<div>CONSTRUCTION SUMMARY</div> <div>Legacy Hill - Trinigroup Development Inc.</div>				
PURCHASER: Morven Songzhen CHAN			RECEIVED MAY 10 2024 TEL: RES.: 416-666-1628	
LOT / PHASE 4 / 1	REG. PLAN #	HOUSE TYPE Villa 6 Elev 2

Villa 6 36' Lot

MAIN LEVEL

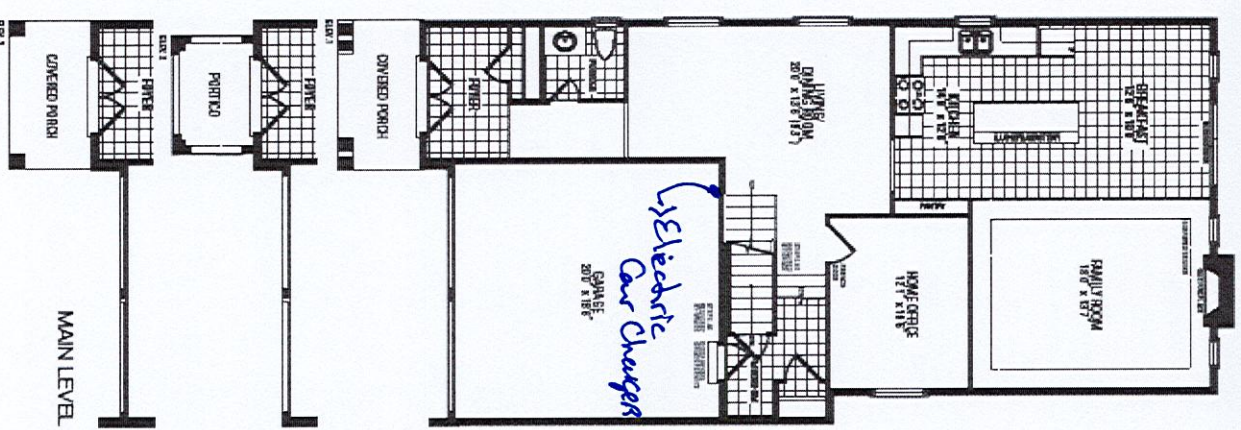
* 10 Ft Ceiling 1st Floor *

UPPER LEVEL

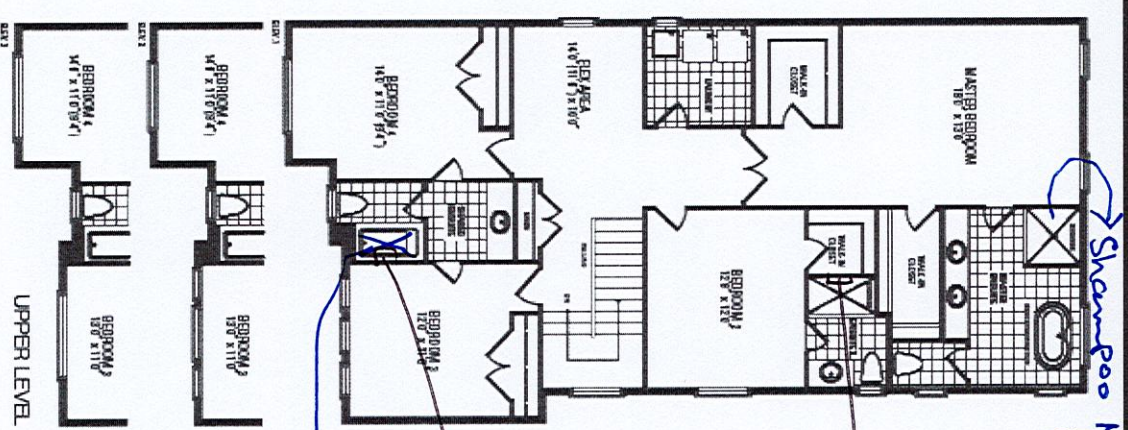
Shampoo Niche 14x20

Niche

Niche

Tub to Shower

1 - PROVISION FOR SHAMPOO NICHE APPROX. 14" WIDE X 20" HIGH AS PER SKETCH – IF CONSTRUCTION PERMITS MASTER ENSUITE, ENSUITE 2 & ENSUITE 3/4 02May24 Note:	
3 - ENLARGED BASEMENT WINDOWS (MAY REQUIRE WINDOW WELLS) - WINDOW IS 30 INCHES X 24 INCHES 10Oct23 Note:	
1 - LOWER LEVEL - BASEMENT 8 FOOT 6 INCH CONCRETE POUR - MEASURED FROM TOP OF FOOTING TO TOP OF FOUNDATION WALL 10Oct23 Note:	
1 - FIRST FLOOR INCREASE CEILING HEIGHT FROM 9 FEET TO 10 FEET 10Oct23 Note:

1 - ENSUITE 3/4 - TUB TO SHOWER CONVERSION - 5 FOOT SHOWER WITH SLIDING GLASS CHROME DOORS IN LIEU OF TUB INCLUDES SHOWER POT LIGHT 02May24 Note:	
--	--
